Techno Fiber Ltd.(11518) Network Clothing Ltd.(10863)

Afiz complex, Chowdhybari, Vora, Gazipur, Bangladesh

28.MAY.2014

Identified Priority 1 Concerns

Lateral load resisting system appears to be lacking from the structural design

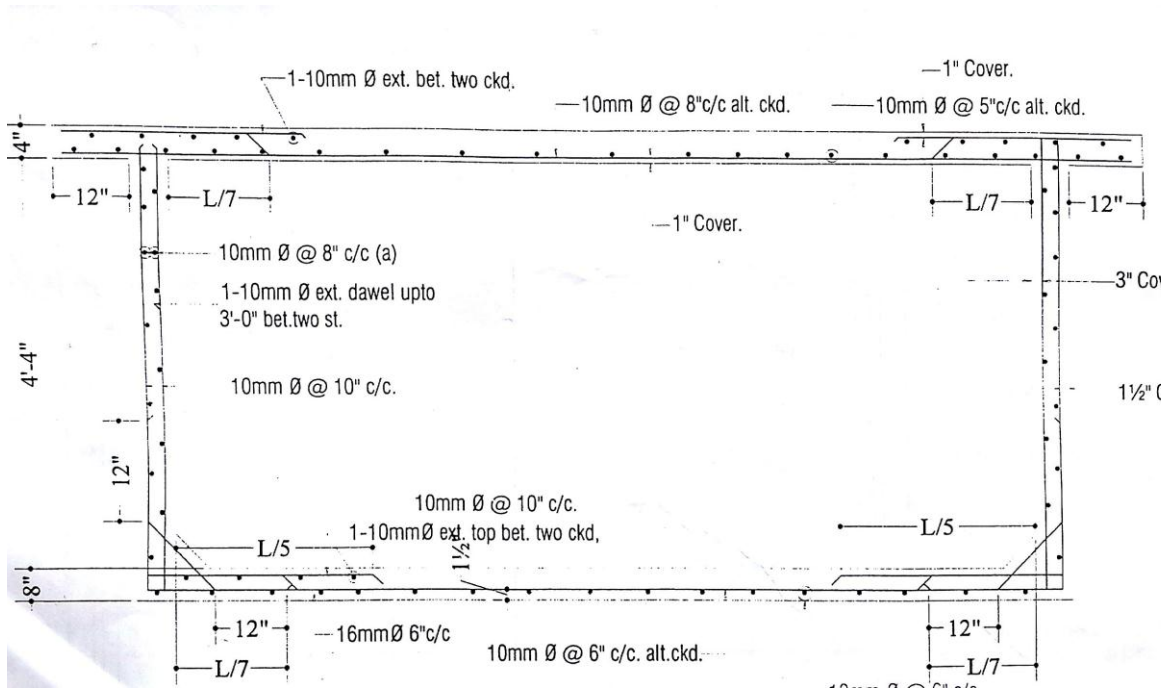
The overall structural arrangement in buildings does not appear to have any rational form of lateral stability system to resist the wind or earthquake loads. It is essential to design for lateral loads. We require that these items be investigated as part of a Detailed Engineering Assessment.

5	1st Priority 2 - Steel roof truss added over roof to form dining area	If found deficient, appropriate modifications to the roof truss to be made to ensure safety of the structure. Drawings to be updated accordingly with full structural details	6-months
6	1st Priority 3 - Lateral load resisting system appears to be lacking from the structural design.	Building Engineer to carry out structural analysis to justify the building performance with regard to the lateral load resisting system. Alternatively, this can be carried out as part of a Detailed Engineering Assessment.	6-weeks
7	1st Priority 3 - Lateral load resisting system appears to be lacking from the structural design.	If the building is found not to comply with the performance conditions, remedial works to be designed and implemented to ensure satisfactory lateral stability.	6-months

Drawings do not show the framing plans or supporting structure for the water tank

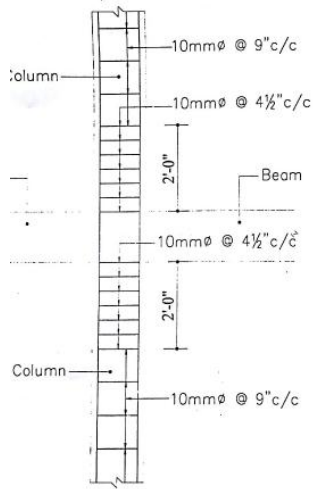
Although the water tank RC detail is provided, there are no location plans or overall framing plans in the drawings.

The supporting structure (above the staircase shaft) is also missing.

Due to the size of the water tank, the structure of the supporting elements should be evaluated and documented in the drawings.

Item No.	Observation	Recommended Action Plan	Recommended Timeline
8	2nd Priority 3 - Drawings do not show the framing plans or supporting structure for the water tank.	Building Engineer to check the record drawings/as built drawings for consistency with the as-built structural condition, and make modifications to the drawings where necessary	6-weeks
9	2nd Priority 3 - Drawings do not show the framing plans or supporting structure for the water tank.	Detailed Engineering Assessment to be carried out to determine unknown areas of the structure in order to complete the compilation of the as-built structural drawing records.	6-months
10	3rd Priority 3 - As-built concrete does not match with the drawing specifications	Building Engineer to check the record drawings/as built drawings for consistency with the as-built structural condition, and make modifications to the drawings where necessary	6-weeks

As-built concrete does not match with the drawing specifications

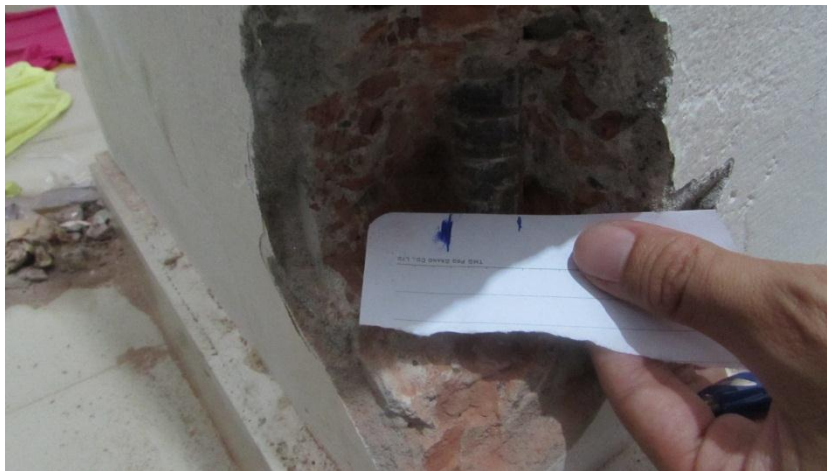
Column material in drawing inconsistent with out side

11	3rd Priority 3 - As-built concrete does not match with the drawing specifications	Detailed Engineering Assessment to be carried out to determine unknown areas of the structure in order to complete the compilation of the as-built structural drawing records.	6-months
